Access Compliance Report

Public Rights-of-Way

Intersection ID: 54465	Main Street: RUPELL_DR	Cross Street: COLLINGHAM_DR	Location: NE
ADA ID: 1C83D84A1869	Ramp Type: BlendTrans1	Initial Pass/Fail: Fail	Overall Compliance: No
		Severity Score: 8.75

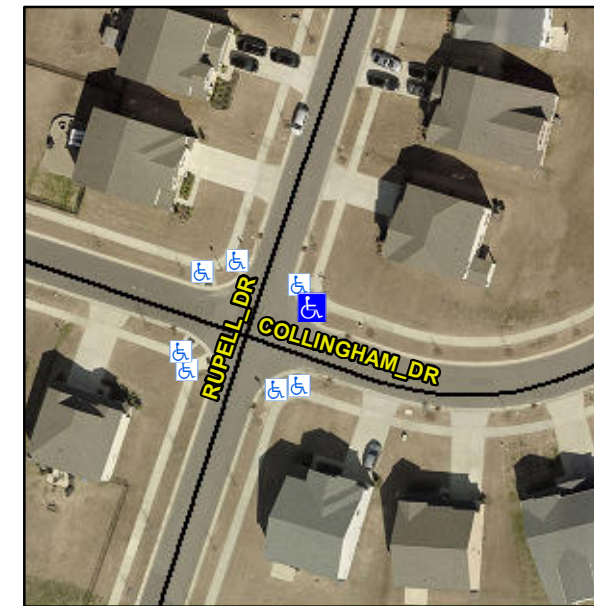
R304.5.1

Compliance	Description	Data	Compliance	Description	Data
N/A	Ramp Length (in)	97.0	Yes	BlendTrans Slope (%)	2.4
No	Ramp Width (in)	46.0	Yes	BlendTrans XSlope (%)	2.0
N/A	Flare Type LT	N/A	N/A	Flare Type RT	N/A
N/A	Flare Slope LT (%)	N/A	N/A	Flare Slope RT (%)	N/A
N/A	Flare Traversable LT?	N/A	N/A	Flare Traversable RT?	N/A
N/A	Landing Length (in)	N/A	N/A	DWS Provided?	N/A
N/A	Landing Width (in)	N/A	N/A	DWS Contrast?	N/A
N/A	Landing Slope (%)	N/A	N/A	DWS Length (in)	N/A
N/A	Landing X Slope (%)	N/A	N/A	DWS Full Width?	N/A
N/A	Landing Curb? (Y/N)	N/A	N/A	DWS Offset (in)	N/A
N/A	Shared Landing?	N/A			
N/A	Gutter Ponding?	N/A	N/A	Gutter Slope (%)	N/A
N/A	Gutter Lip Ht (in)	N/A	N/A	Gutter X Slope (%)	N/A
N/A	Painted X Walk1?	No	N/A	Painted X Walk2?	N/A
	X Walk 1 Direction	To SW		X Walk 2 Direction	N/A
	X Walk 1 Width (in)	N/A		X Walk 2 Width (in)	N/A
	X Walk 1 Slope (%)	2.3		X Walk 2 Slope (%)	N/A
	X Walk 1 X Slope (%)	1.0		X Walk 2 X Slope (%)	N/A

Remove & Replace Curb Ramp With Two New Directional Ramps or Equivalent.
